## ANN ARBOR HISTORIC DISTRICT COMMISSION

### Staff Report

**ADDRESS:** 419 N Ingalls Street, Application Number HDC21-019

**REPORT DATE:** February 11, 2021

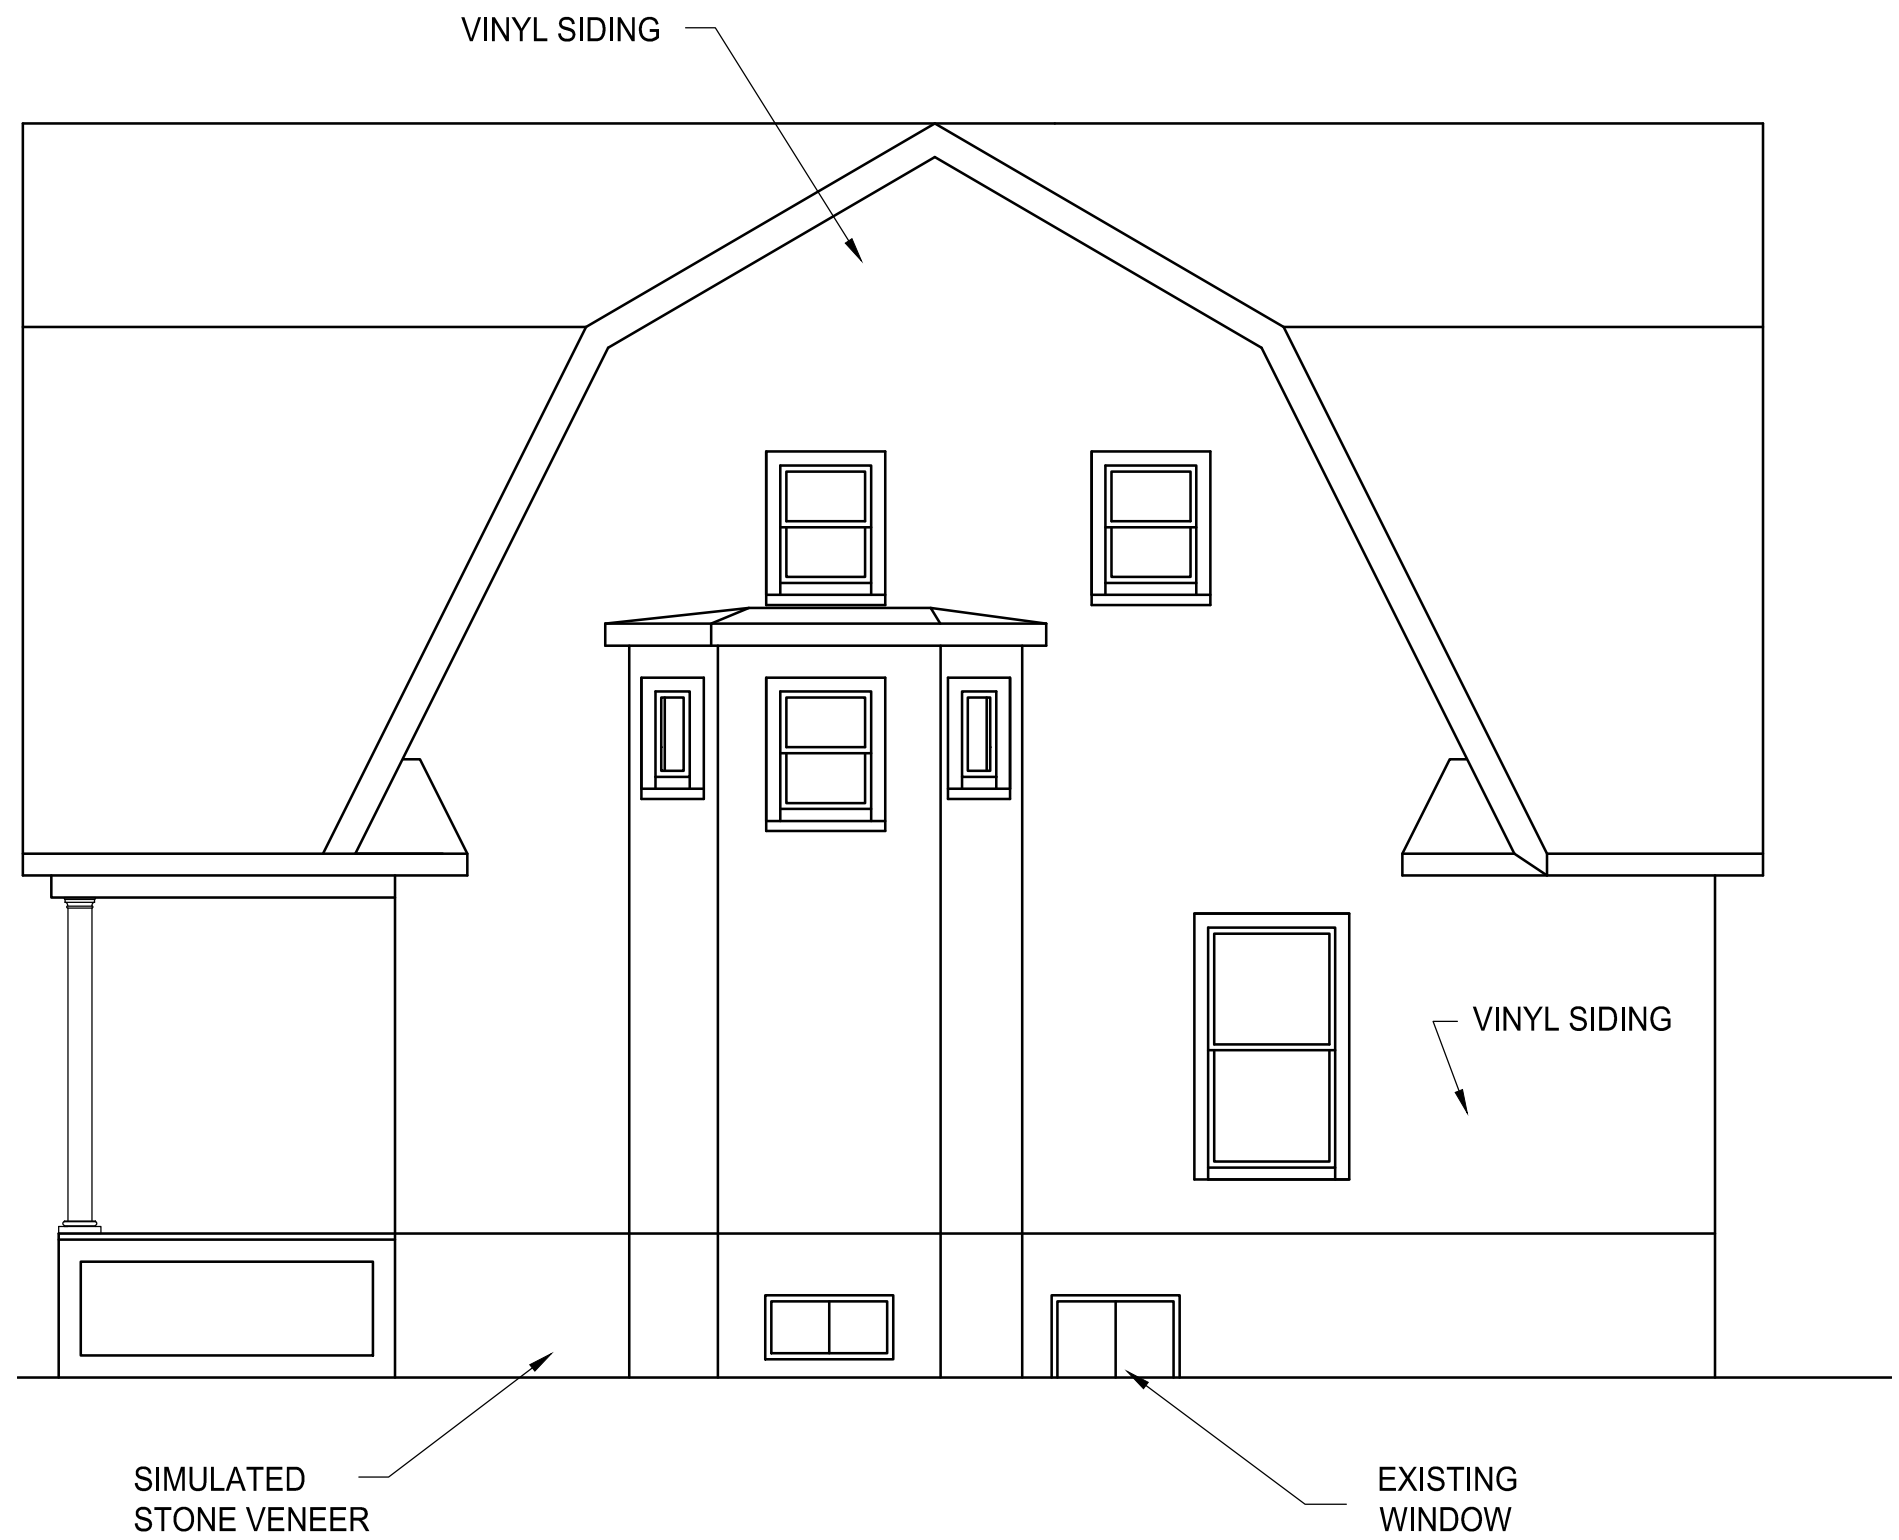
2. This request for an egress window is to allow one of the bedrooms to be constructed in the basement. It would be located on the south elevation, about a foot from the front corner of the house. The existing window opening would be cut deeper to match the existing width. The well would be pressure treated wood that is roughly 40" wide, roughly 38" from the house, and approximately 40" deep, per the application sheet of additional information. The windows would be Andersen 400 series vinyl-clad wood casements. The wall of the well would extend approximately 4" above grade.

4. This is an inappropriate location for an egress window since it is on a very prominent, character-defining elevation that is only a foot from the front of the house and clearly visible from the city right-of-way. A bollard required to keep a car from driving into it will

make the work even more conspicuous. An egress window and well in this location would be incompatible with the historic character of the house. Enlarging this window would be a visual disruption that would diminish the house's character. The historic opening should not be replaced with a larger sash. This work does not meet the Secretary of the Interior's Standards 1, 2, or 9. Staff recommends denial of the application.
